# Proposal of Equivalence Criteria

42<sup>nd</sup> TF TA  
26<sup>th</sup> Jan 2026

**JAPAN AUTOMOBILE STANDARDS INTERNATIONALIZATION CENTER**

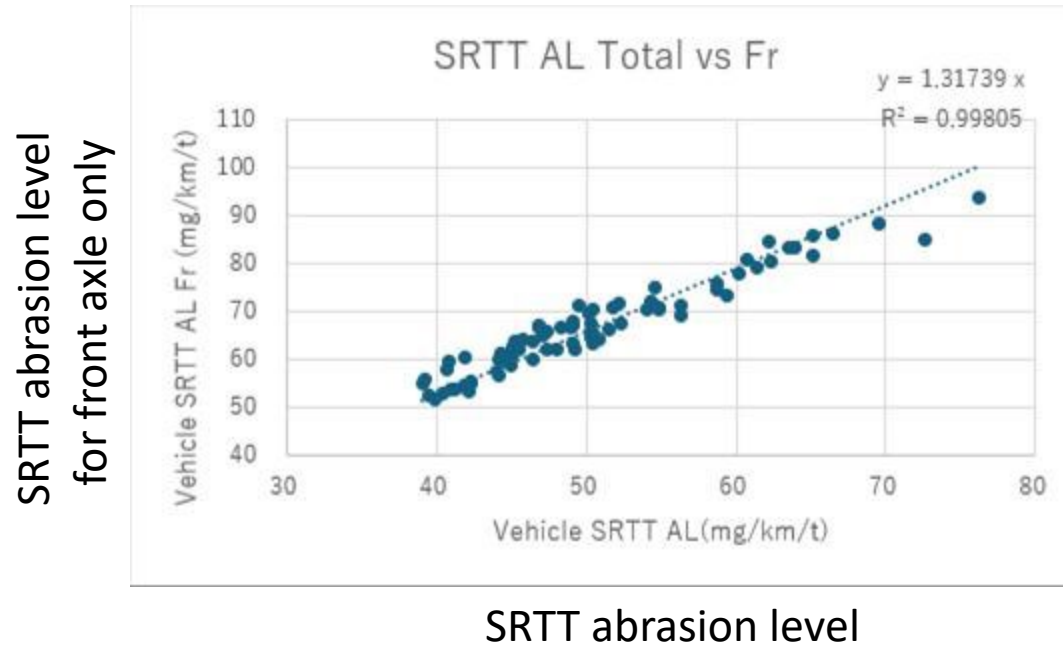
- ✓ At TFTA 41<sup>st</sup> session, JASIC proposed narrowing the abrasion level range of the SRTT to effectively establish testing under ‘same severity’ conditions as direction for improving the accuracy of the drum test method.
- ✓ Based on this idea, we propose a tentative improvement to the test accuracy of the 83rd GRBP by tightening the upper limit of the reference abrasion level.
- ✓ We propose a candidate upper limit of 135 mg/km/t for SRTT17S and SRTT17W, based on JRC’s recommendation reported in TA-42-3.

The abrasion level of the SRTT17S reference tyre for all types of surface shall be in the range between 45 mg/(km·t) and ~~190~~ **135** mg/(km·t).

The abrasion level of the SRTT17W reference tyre for all types of surface shall be in the range between 35 mg/(km·t) and ~~165~~ **135** mg/(km·t).

TA-42-3 JRC analysis ETRTO-JASIC database

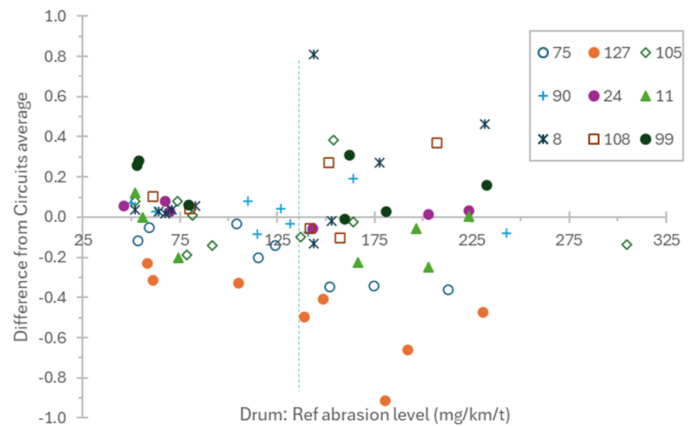
For some tyres higher abrasion levels resulted in higher differences from the average abrasion level index of the circuits.

Maybe (like temperature) the test severity impacts some tyres differently than the reference tyre.

A maximum upper level of around 135 mg/km/t for the reference tyre is recommended

No conclusion can be drawn for the lower end (available data down to 45 mg/km/t)

JASIC analysis

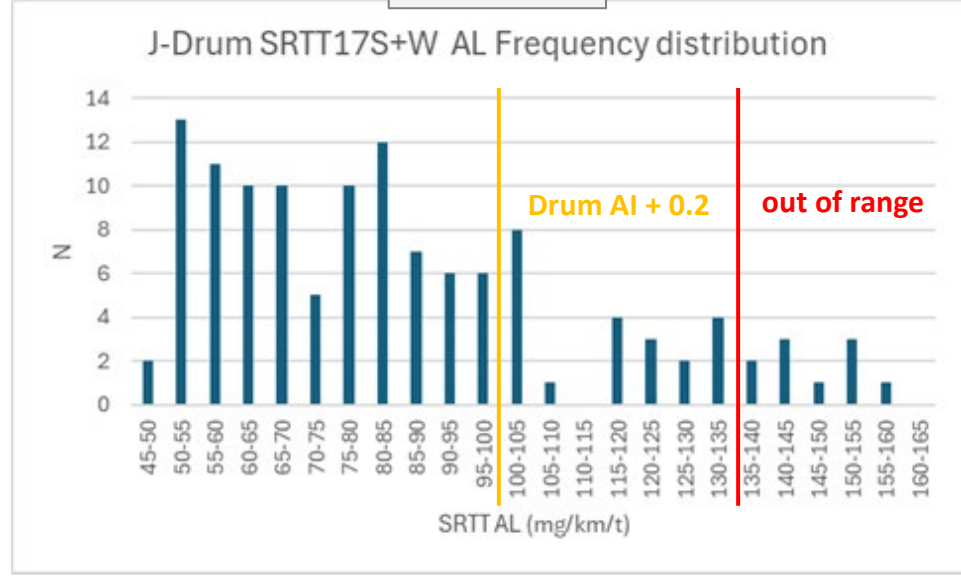
- ✓ Specifically, when the abrasion level of the reference tyre is between 100 mg/km/t and 135 mg/km/t, 0.2 is added to abrasion index of the drum test results.

- ✓ The average outliers where the drum test results are smaller than the vehicle test results are between 0.4 (a difference of 0.25 or more) and 0.45 (a difference of 0.3 or more). Taking the COP 0.25 into account, a correction of 0.15 to 0.2 is appropriate.

**Upper limit**  
135 mg/km/t

**Correction applied**  
100 to 135 mg/km/t

In case a drum test is conducted and the abrasion index of the reference tyre is between 100 mg/km/t and 135 mg/km/t, the abrasion index obtained from the test results plus 0.2 shall be used as the abrasion index.
